Description of Project Changes & Responses to Planning Board Questions

Revised Site Plan

**Meinig Fieldhouse
Indoor Sports and Recreation Facility**

City of Ithaca Planning Board
September 26, 2024

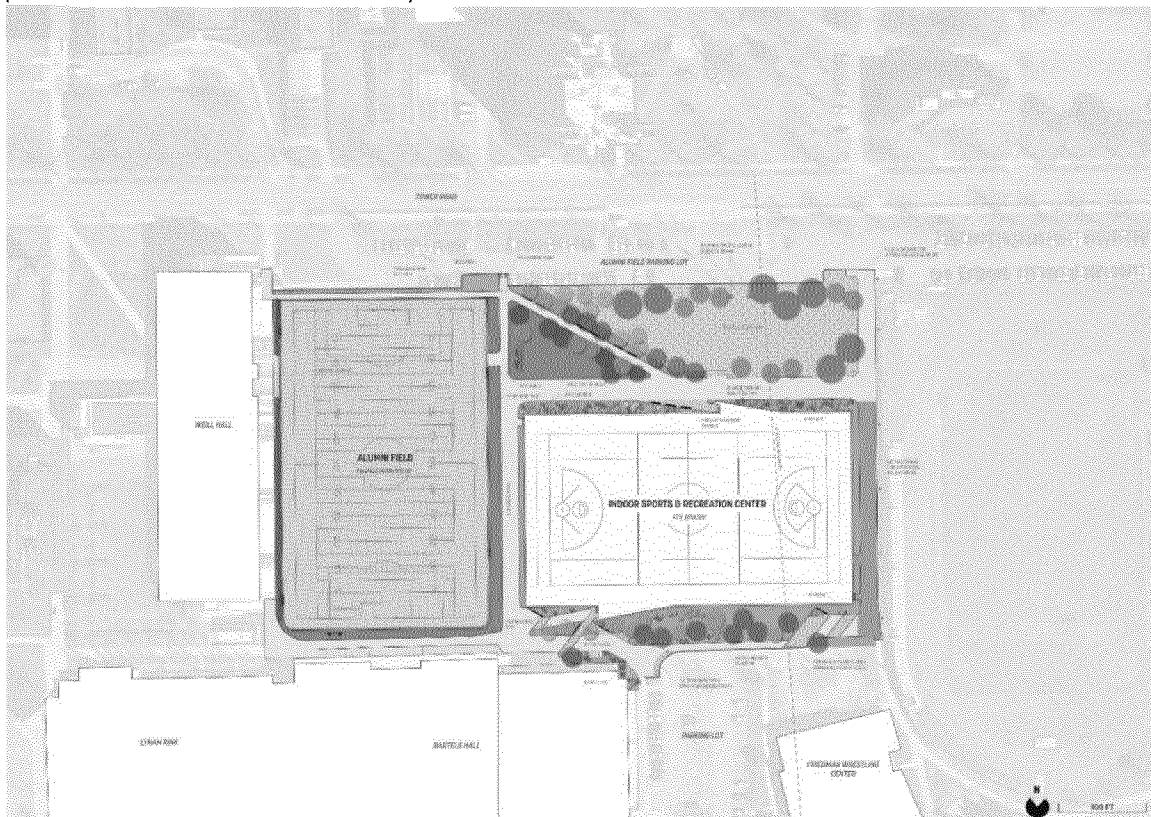
As previously noted in the December 2023, Site Plan Review Application, Cornell University is proposing to construct the Meinig Fieldhouse, an indoor sports and recreation center, on Cornell's Central Campus in the area currently occupied by Robison Alumni Fields. Since the original submission, the project scope has been revised to show a new multi-purpose athletic field in the location of the previously proposed field hockey outdoor turf field to the west of the proposed Meinig Fieldhouse building. The previous submission included a proposed 77,354 SF field hockey field with amenities. The revised project scope includes a proposed 92,098 SF (93,098 SF with perimeter curb) multi-purpose synthetic turf athletic field that will support a variety of sports activities for much of the year. The updated site plan removes several elements that were previously proposed for the field hockey field, including the removal of the flagpole, team storage area, team shelters, press box, and spectator seating. The proposed scoreboard has been relocated to the southern portion of the field.

Due to the field size expansion, the sports lighting poles have shifted slightly further apart. The sports lights to the west (F3-F4) of the multi-purpose field have been shifted towards the field corners to avoid existing underground utilities and surface features remaining on site. Due to this shift, these two poles now have a mounting height of 80 feet, while F1-F2 remain at a mounting height of 70 feet.

Revised Site Access and Circulation

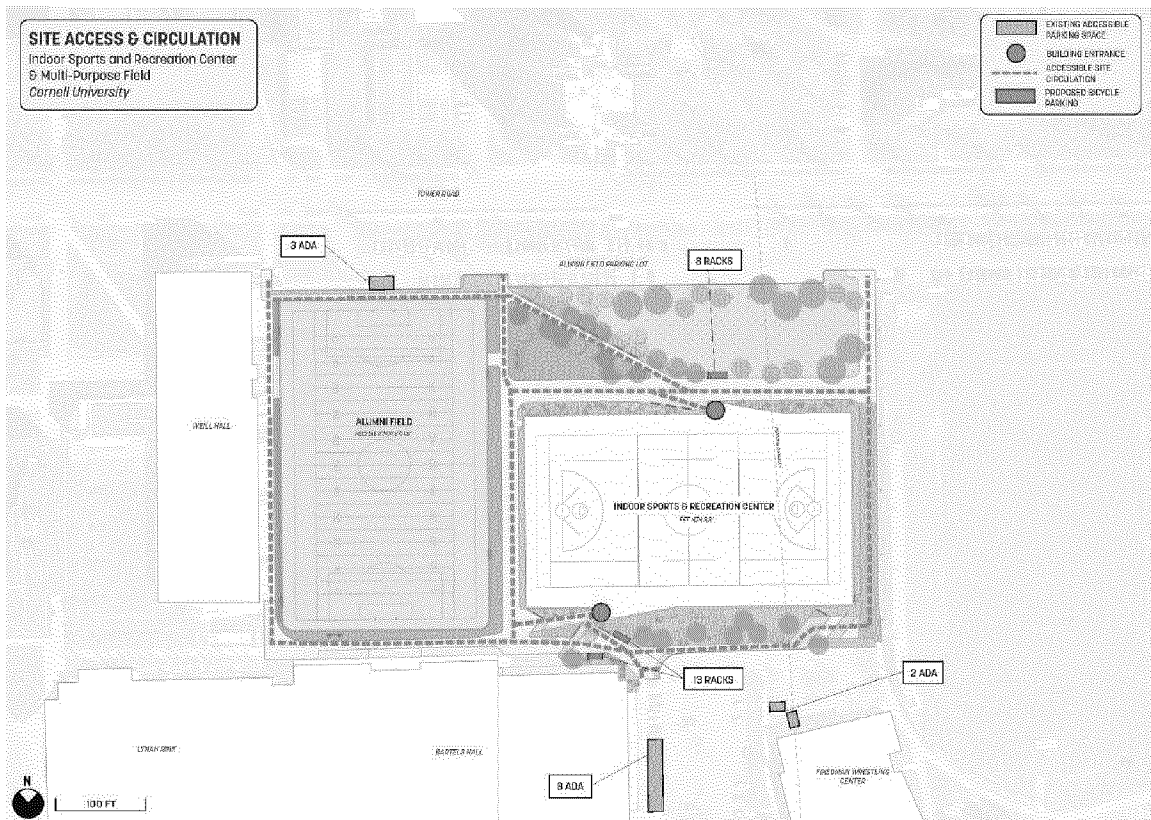
A revised Site Access and Circulation diagram is provided below. As noted in the original Site Plan Review Application dated December 2023, very little parking is expected to be needed daily as the facility is primarily expected to be used for students for practice, recreation, and club play. Bicycle parking on the site has been reconfigured and includes a total of 21 bicycle parking spaces separated into three bicycle parking facilities. As noted in the December 2023 submission, bicycle parking facilities will be easily accessible from pedestrian or fire access pathways and will not intrude into these walkways.

Due to changes to the site layout, only one (1) non-ADA parking space will be removed from the Bartels Lot to the south because of the proposed project. Three (3) ADA accessible parking spaces will remain in the Alumni Lot to the north, and 8 ADA accessible parking spaces in the Bartels Lot to the south.

Revised Operations and Maintenance Strategy

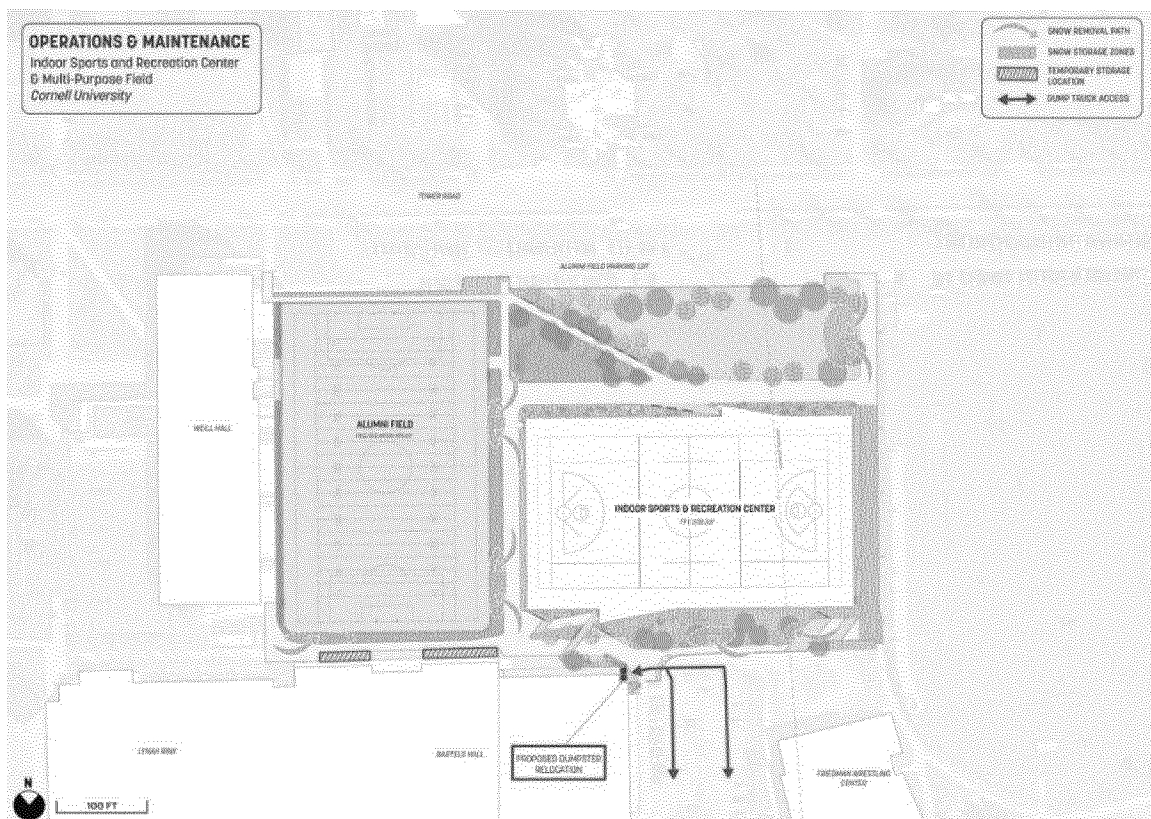
The revised Operations and Maintenance strategy includes minor modifications to the areas in the site identified for piling snow, including removal of a snow piling area on the northeastern portion of the field, and relocation of one of the southern snow piling areas. The location of the concrete dumpsters on heavy-duty concrete pads, accessible via flush curb from the parking area adjacent to the Friedman Wrestling Center, remains unchanged from the December 2023 submission. Service access to the Meinig Fieldhouse via 10-foot wide roll-up door, as well as proposed service access drives and delivery routes, remain unchanged from the December 2023 submission.

Landscaping and Planting Plan

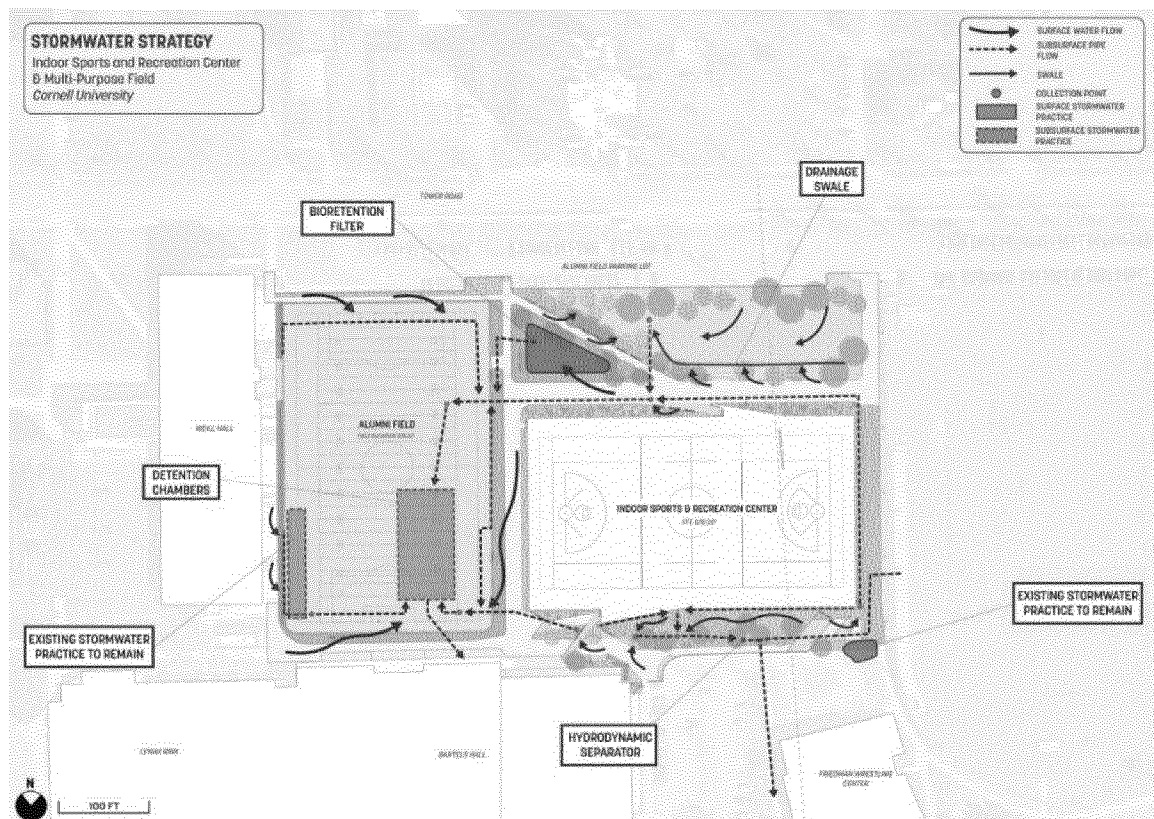
As noted in the December 2023 submission, natural landscaping around the building will include a variety of species with a strong emphasis on using native, non-invasive plant materials. The City of Ithaca Planning Board requested additional information regarding tree clearing and protection and tree planting, as well as an updated planting plan. During construction, a total of 18 *Quercus rubra* will be removed, and 60 trees will be planted on site, resulting in a net addition of 42 trees on the site. As noted in the Planting Plan under separate cover, the trees to be planted include:

1. (11) 2.5" caliper *Acer rubrum* 'Redpointe'
2. (14) 8-10' height *Amelanchier x grandiflora* 'Autumn Brilliance'
3. (18) 8-10' height *Betula papyrifera* 'Oenci'

4. (10) 8-10' height *Cercis canadensis* 'Northern Strain'
5. (7) 2.5" caliper *Ulmus americana* 'Princeton'
